Docket Item # 1
BAR CASE # 2016-0406

BAR Meeting
December 14, 2016

ISSUE: Certificate of Appropriateness – New Construction
APPLICANT: VHD LLC
LOCATION: 699 North Patrick Street
ZONE: CRMU-M

BOARD ACTION: Approved as amended, 6-0

PROPOSED ROOF PLAN

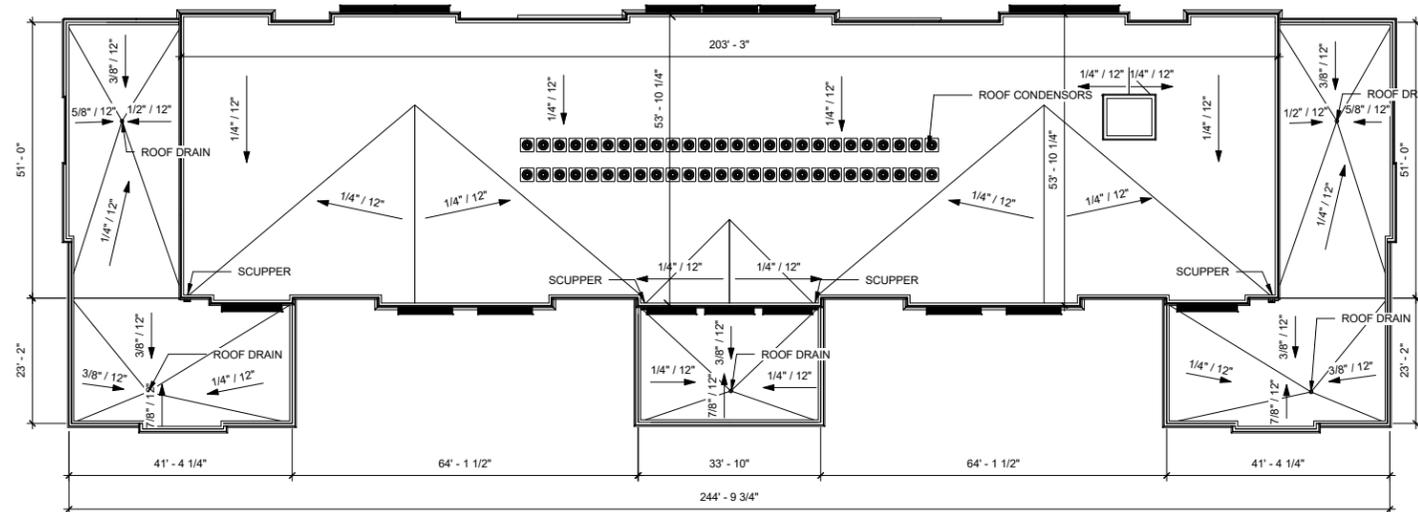
The roof plan indicates that the gangs of residential scale rooftop condenser units will be centered on the roof and, therefore, as minimally visible as possible. In this case, any screening of the equipment would be more visible than the units themselves, so staff supports the requested waiver of the rooftop screening requirement.

PERGOLA DETAILS - WYTH STREET

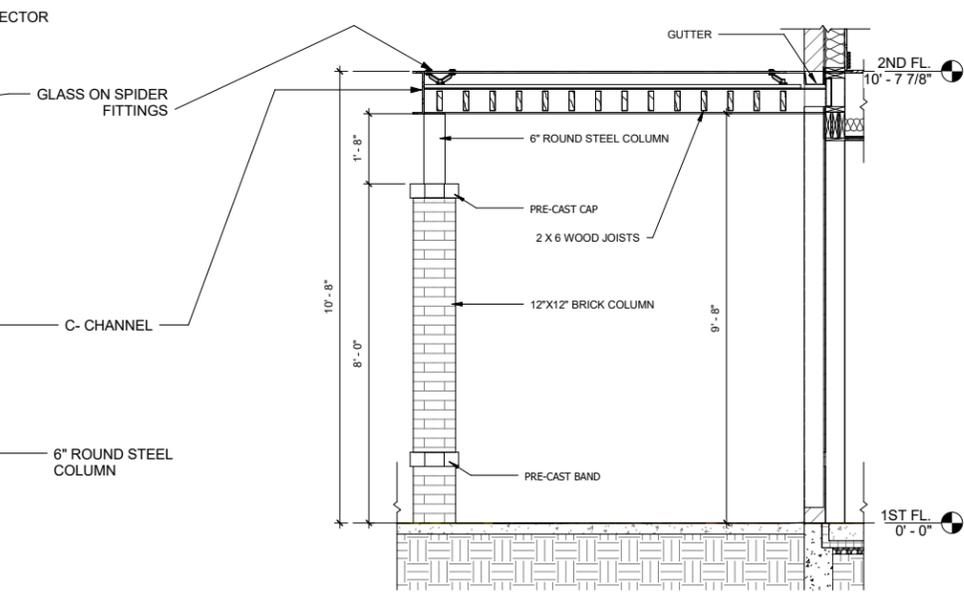
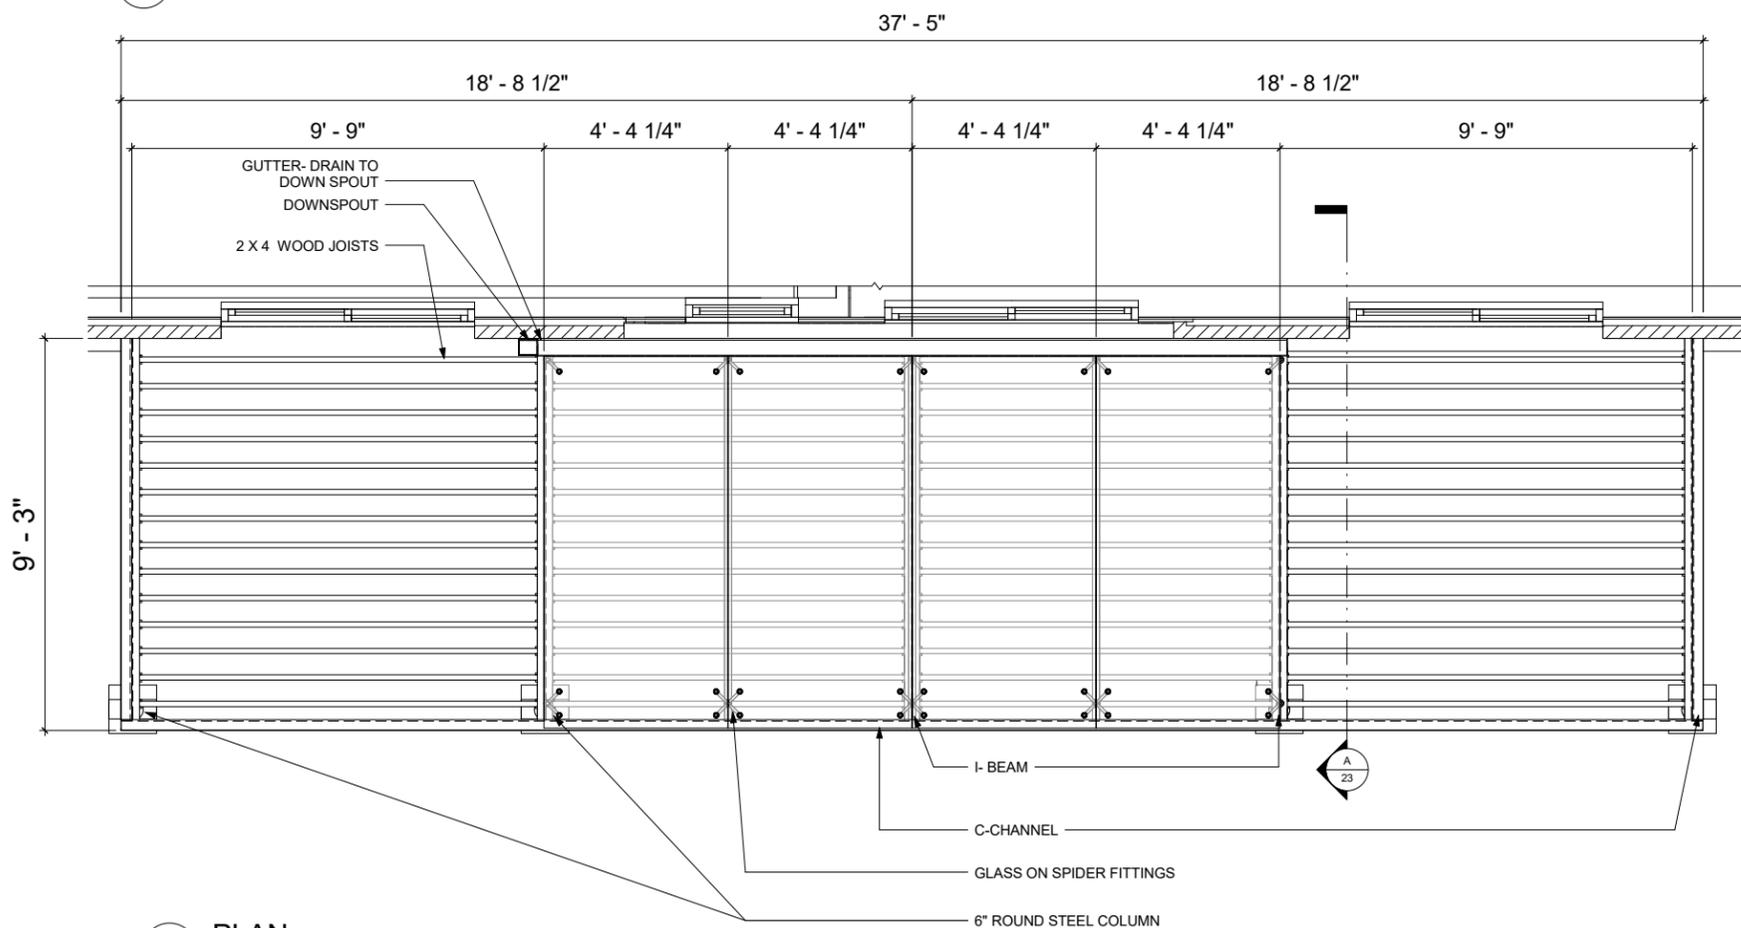
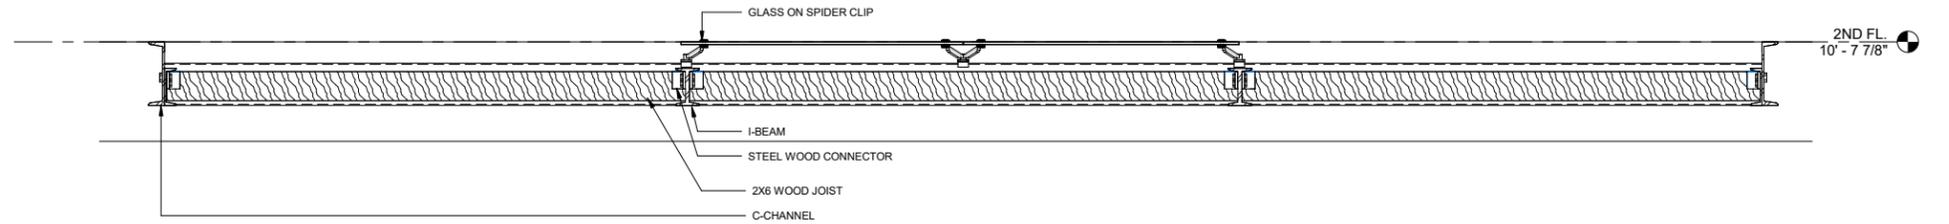
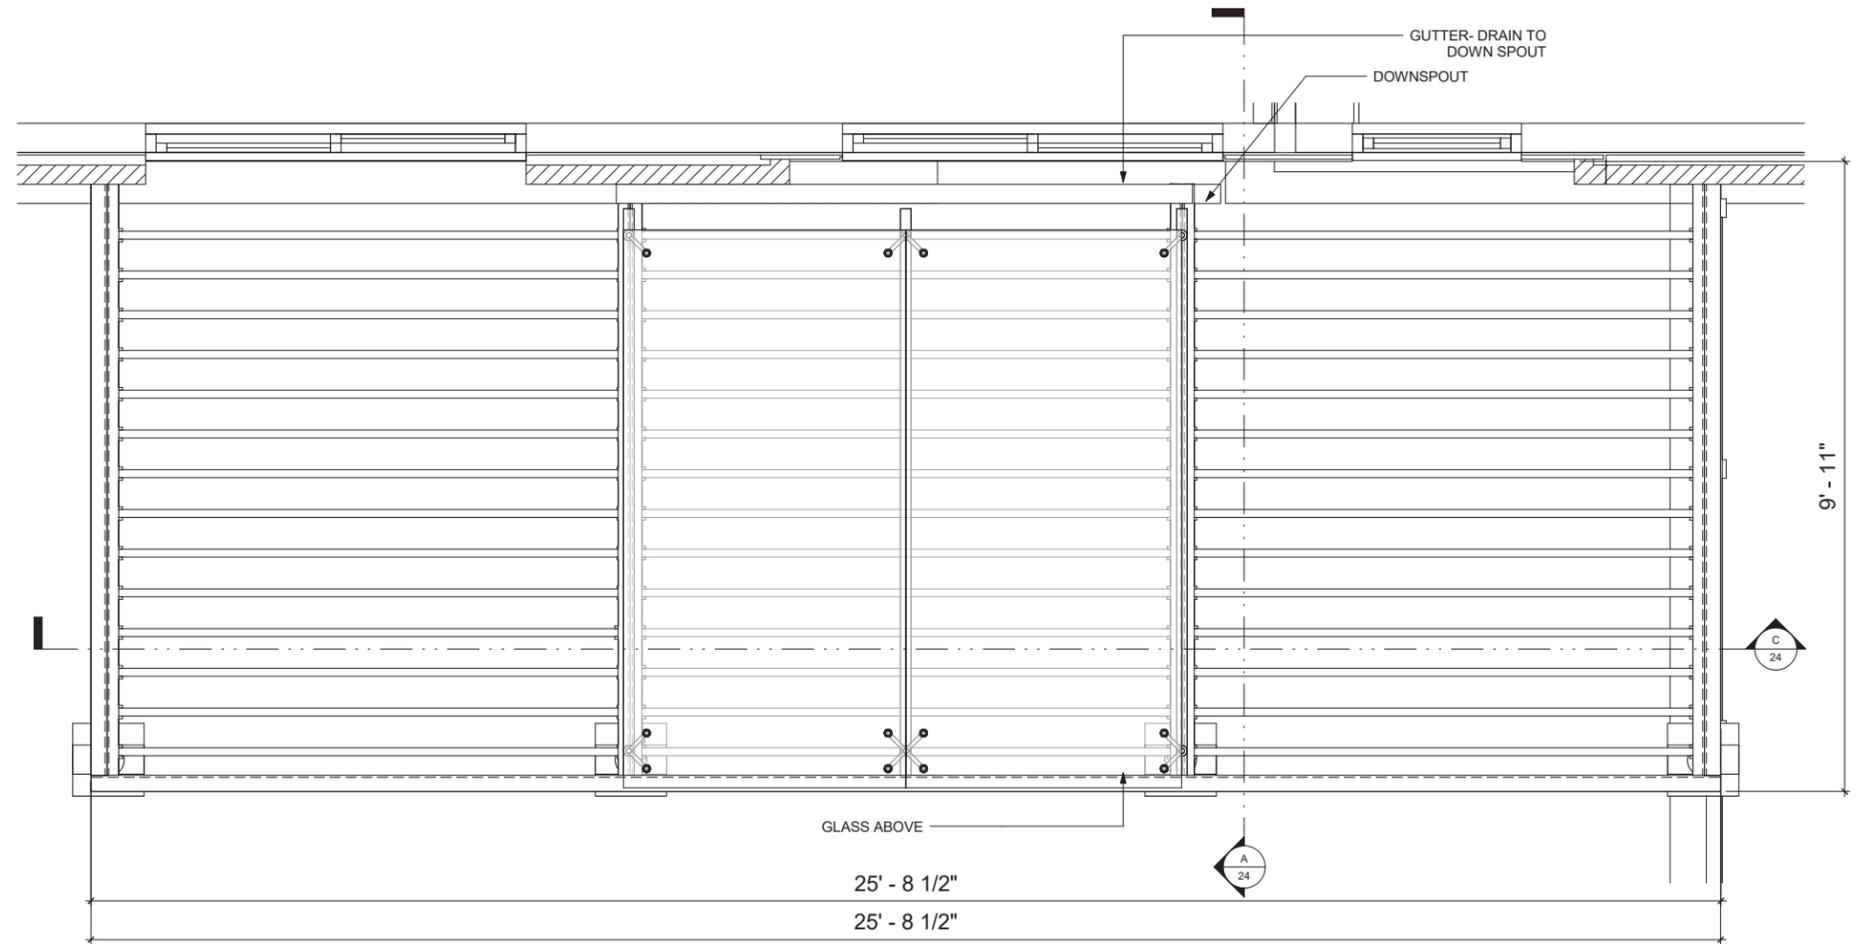
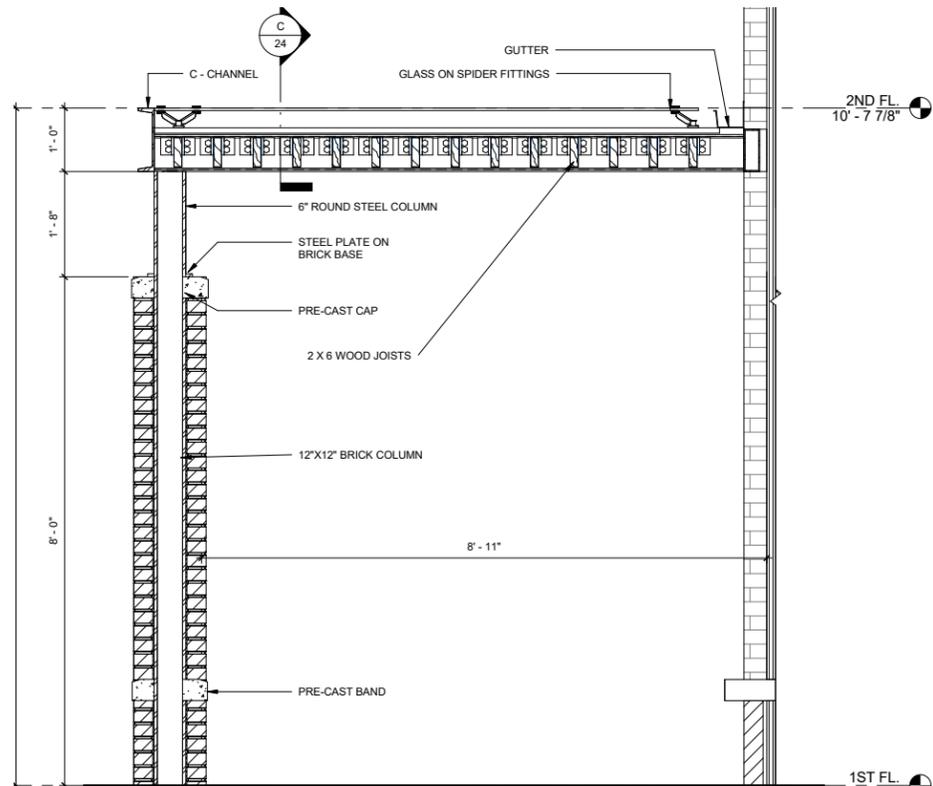
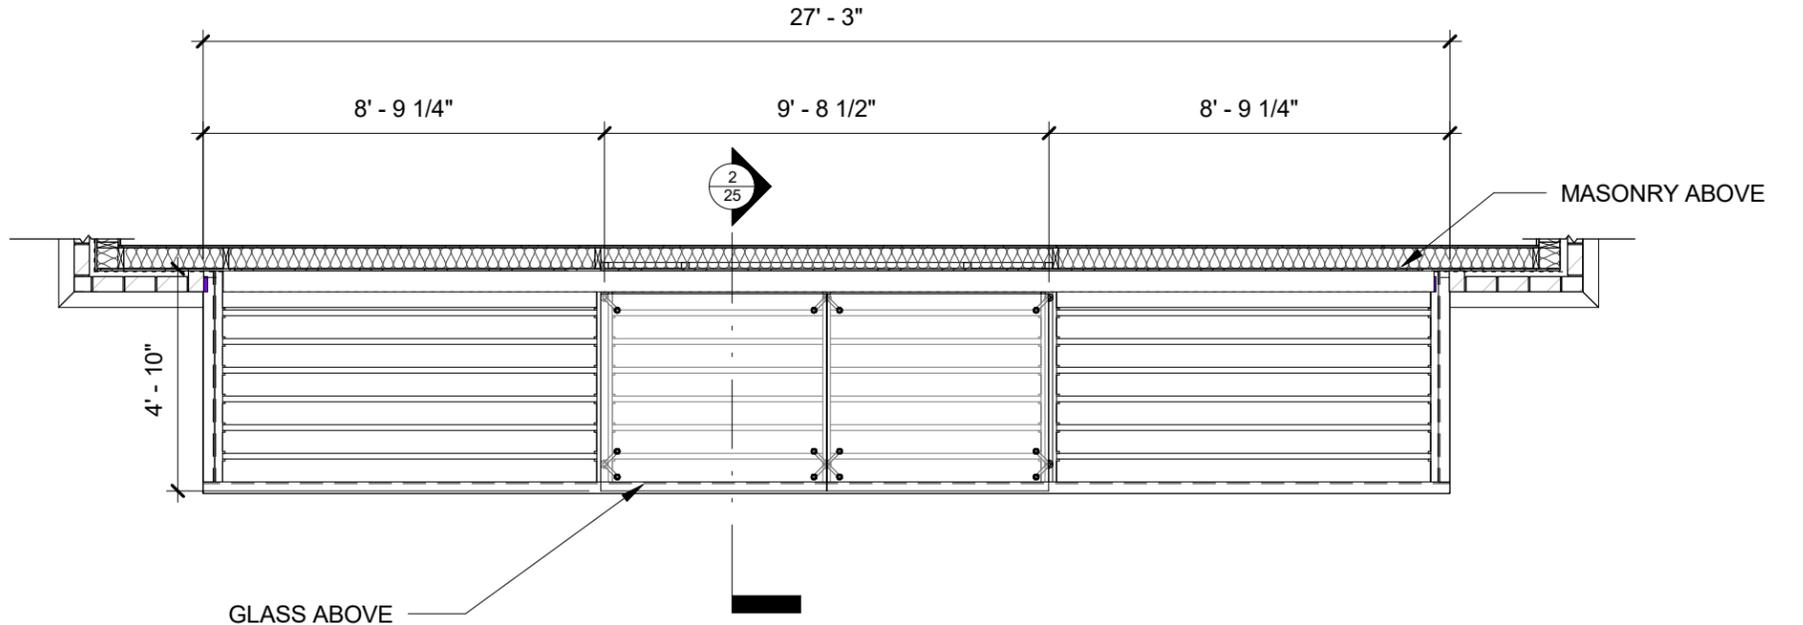
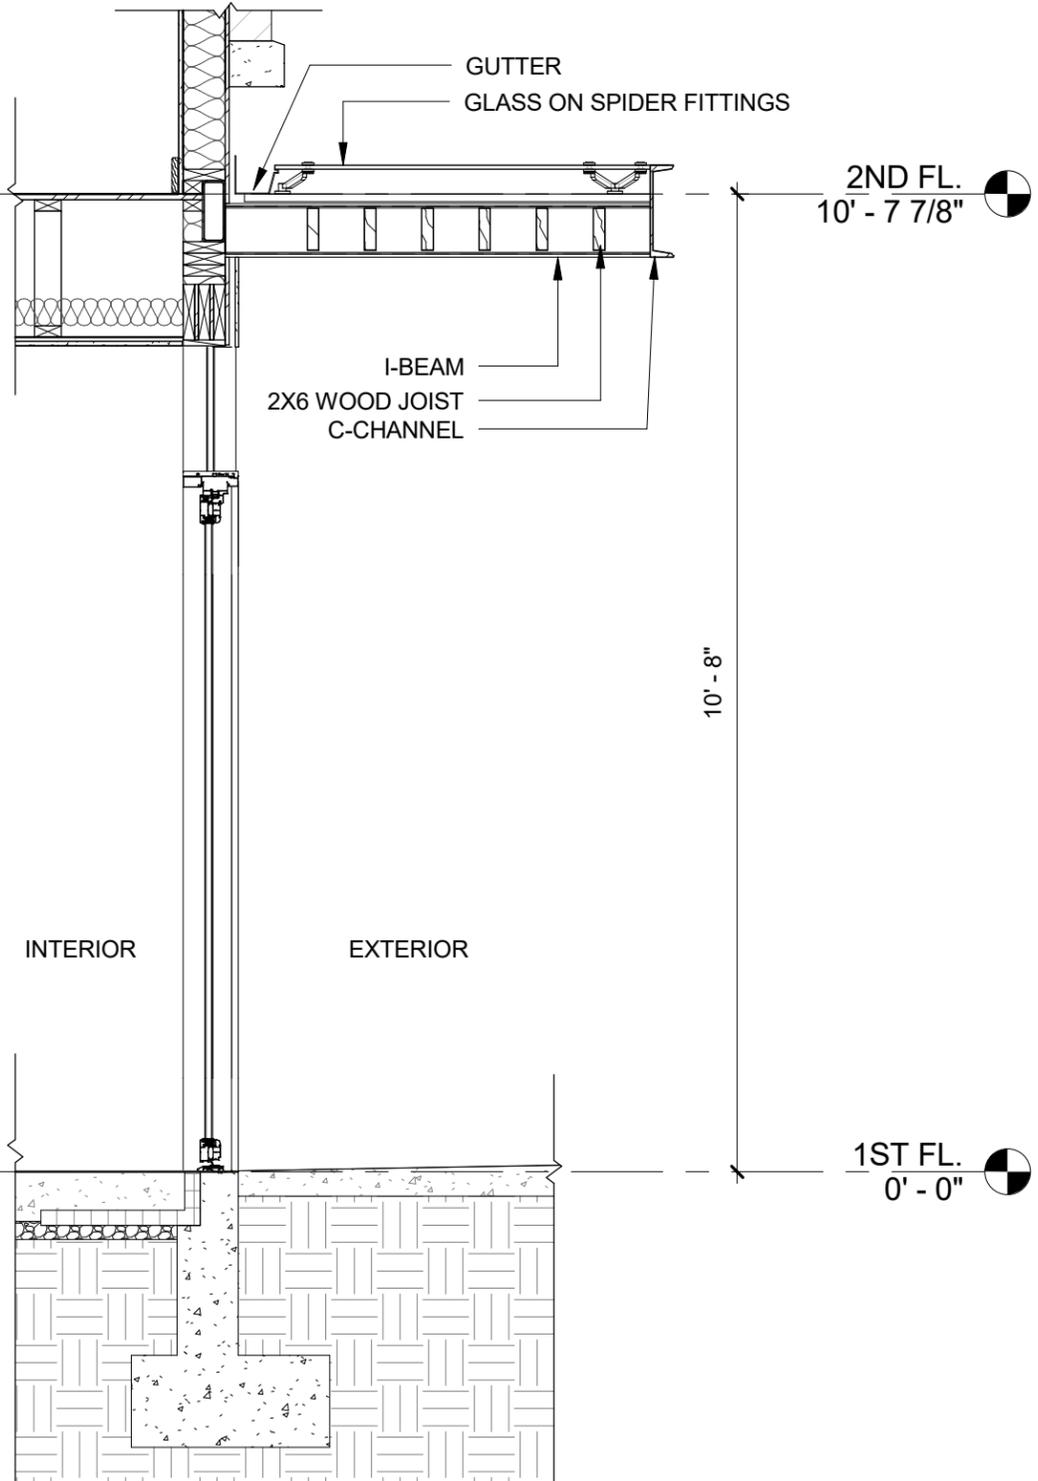
- c. *Final material selection for the pergolas.*

The BAR supported the design evolution of the pergola but expressed concern about the material and color selection and asked the applicant to restudy that element. It was suggested that a high-quality, solid composite material could be used in place of wood and that a more gray color would better relate to the building color scheme. The BAR had considerable discussion regarding the horizontal fiber cement siding, noting that was a very residential material choice. Several members found that the drawings did not adequately convey how the horizontal siding would look at the corners and noted that a traditional vertical 1x4 corner board or similar trim piece would not be stylistically compatible with the overall contemporary aesthetic of a multifamily building. Because of these outstanding items, the BAR conditioned the approval on these few elements returning to the BAR for final approval.

Comment 1: The pergola as proposed was the wrong typology for the overall architecture and the scale was too small and delicate. In addition, the materials, including the brick piers needed refinement and suggested steel in place of the wood as there was no wood in the remainder of the building.

Response 1: The pergola elements have been redesigned to depict a simpler, more durable structure, as a reflection of the transitional architecture of the building. The steel frame will connect directly to the structure of the building. Cross beams which generally bear on top of the pergola frame, are now recessed into the frame, simplifying the profile while still achieving sun coverage, rain coverage at the entry using glass on spider clips and a single story connection to the Watson Reading Room along Wythe Street. The steel columns are wrapped in brick matching the building with a precast cap to further integrate the design of the pergola to the building. The masonry wrapped columns are suited within the context of this site as they reflect the canopy column design of the Charles Houston Recreational Center across Wythe Street.
